February 28, 2019

SUBJECT: Response to Request for Additional Information Regarding Perma-Fix License Application

# NRC Service Provider License Application, Section 5 Through 11

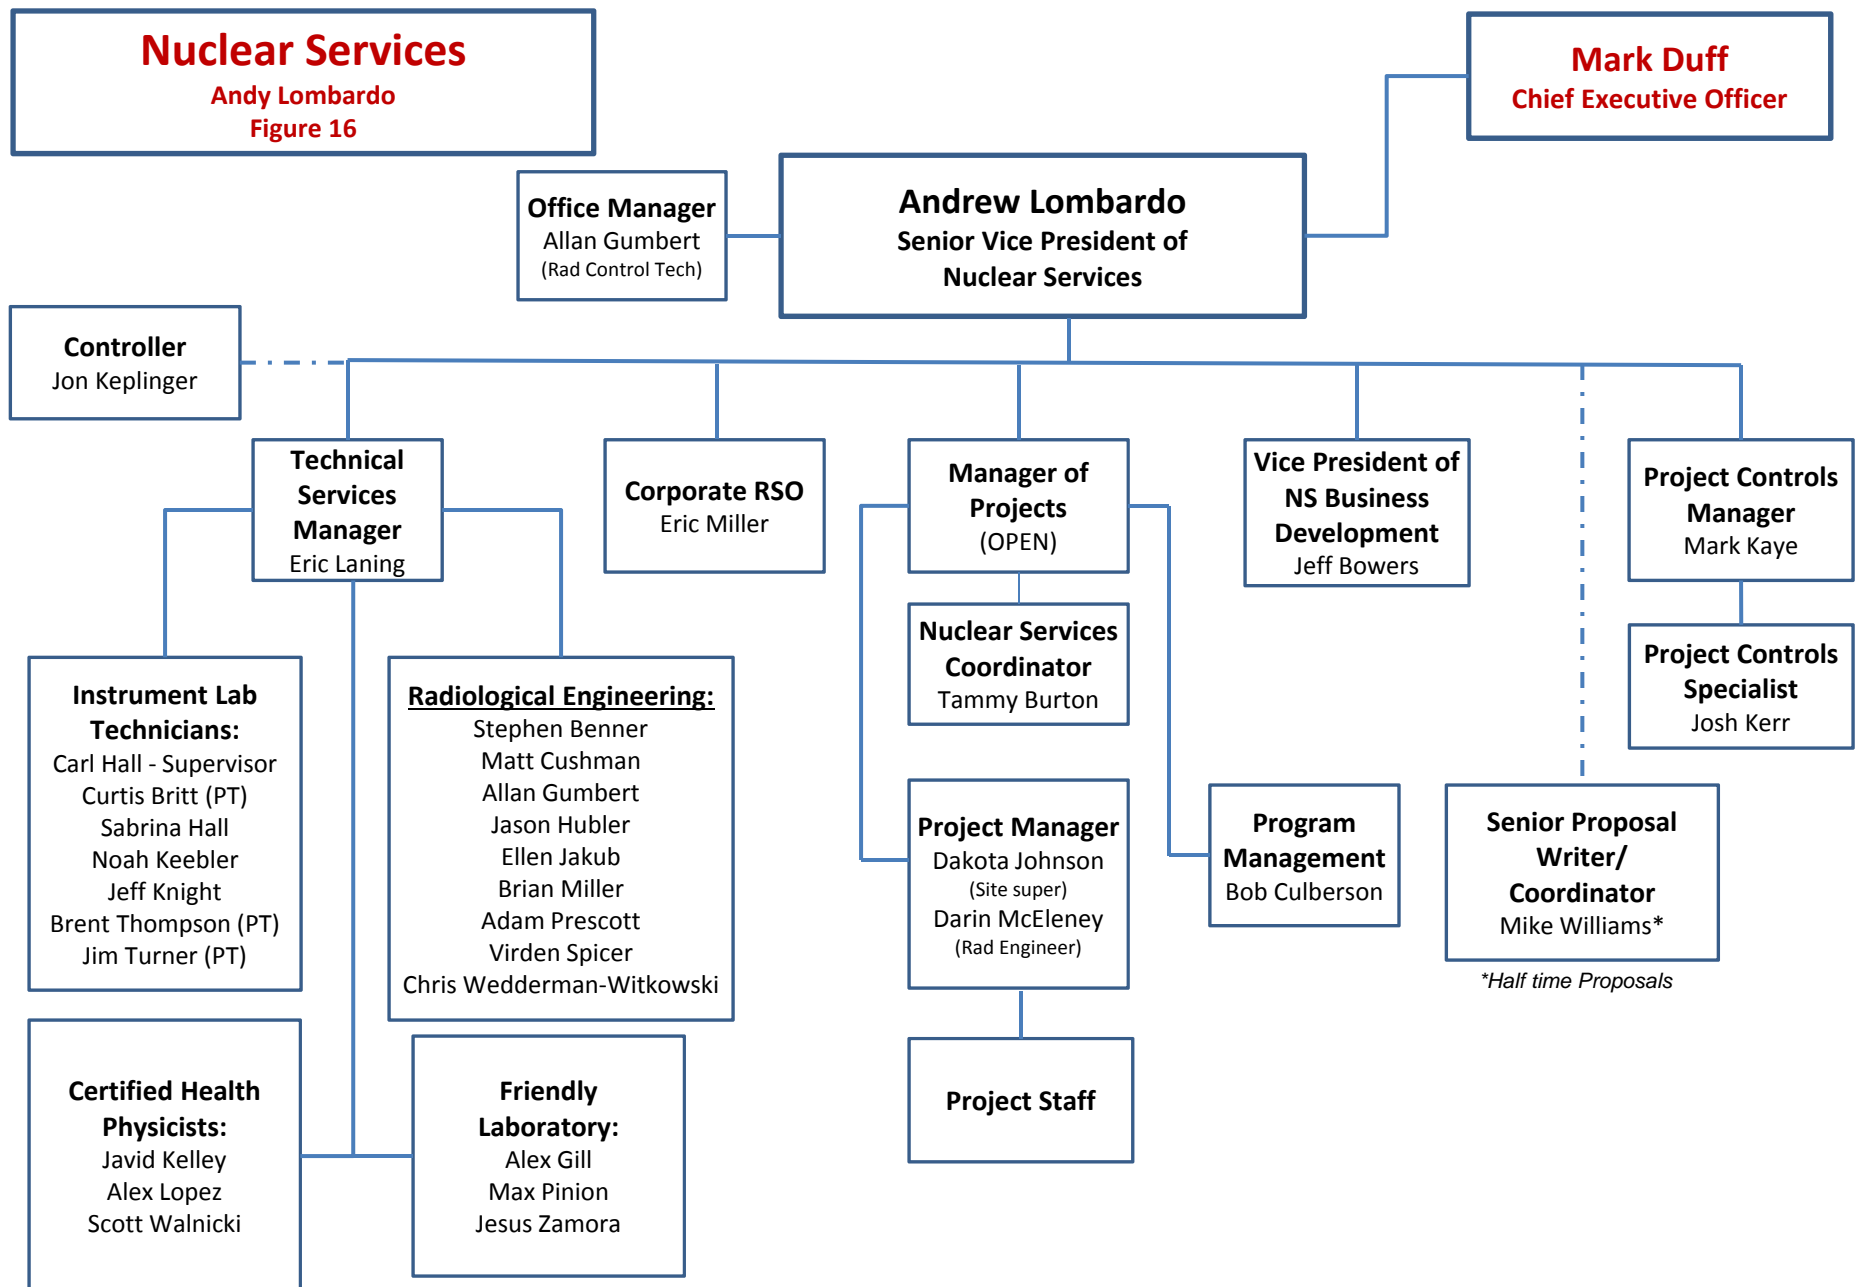
- a. Demonstrate that the RSO has sufficient independence and direct communication with responsible management officials by providing a copy of an organizational chart by position and demonstrating day-to-day oversight of the radiation safety activities;
- b. Confirm that the RSO will be available for emergencies and can be on-site within 24-48 hours, if applicable;
- c. Confirm that the duties of the RSO will include those described in Appendix C of NUREG-1556, Volume 18, Revision 1.

A copy of the Perma-Fix organization chart is provided to address Item 8 a.
